6.0 CONSULTATION & PRE APP RESPONSE

Pre App Feedback & Design Team Response

The design team held a Pre Application meeting with the London Borough of Camden on 29/06/2023. The proposals were well received with a few minor comments. The written feedback and the design team's response is as follows:

Design Response - Entrance

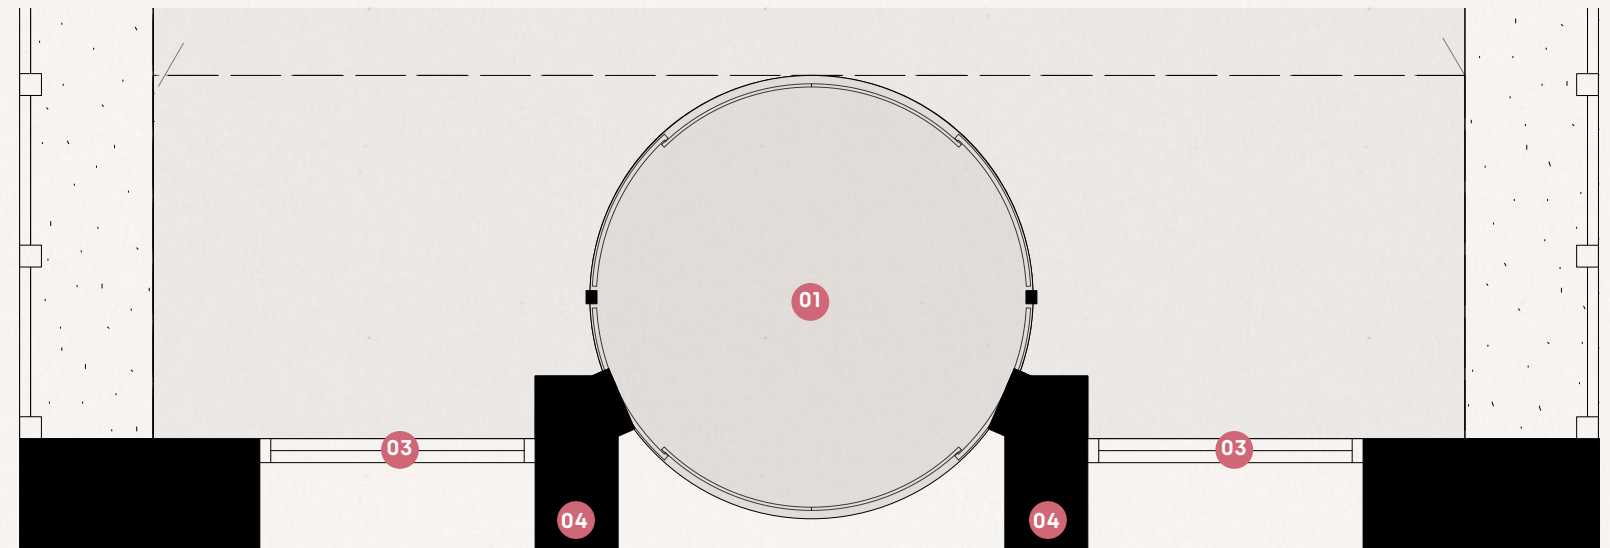
- 'The alteration of the existing entrance doors is acceptable but the loss of any of the original door surround would not be supported.'
- 'The existing stone piers are an important and dignified element of the design of the facade'
- 'Reverting to the original finish would enhance the contribution the building makes to the street scene and conservation area.'

- 'The metal signage obscuring the stone columns either side of the entrance will be removed.'
- 'The entrance columns will be exposed and made good - revealing the original character of the entrance.'
- 'A new circular sliding door will be installed inside the central bay - improving the thermal performance of the Ground Floor whilst allowing for DDA access.'

Existing Elevation - Bayham Street

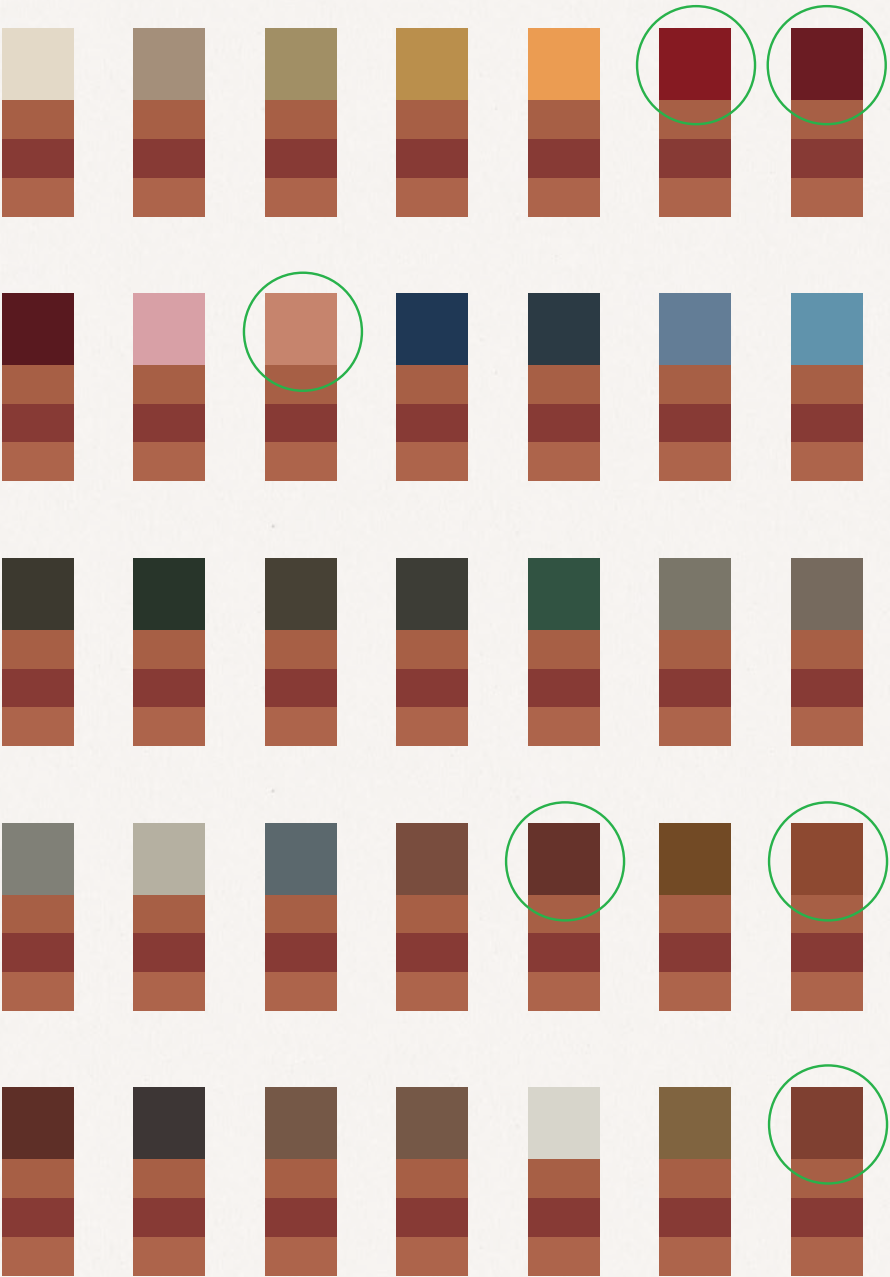
"The removal of the window decals at ground floor is supported and the replacement of the ground floor windows is acceptable. The alteration of the existing entrance doors is acceptable but the loss of any of the original door surround would not be supported. The existing stone, or reconstituted stone, piers are an important and dignified element of the design of the façade despite later cladding. An accessible entrance could be created within the existing structural fabric.

The entrance door has been clad in metal (with permission). However, the stonework beneath is fluted and of decorative quality. Reverting to the original finish would enhance the contribution the building makes to the street-scene and conservation area."

As suggested in the LBC's pre-app comments, the proposal is now to remove the metal fascia and keep the existing stone piers either side of the entrance door integrating a circular sliding door into the central bay (acting as a draught lobby). See entrance redesign proposals appended to the DAS.
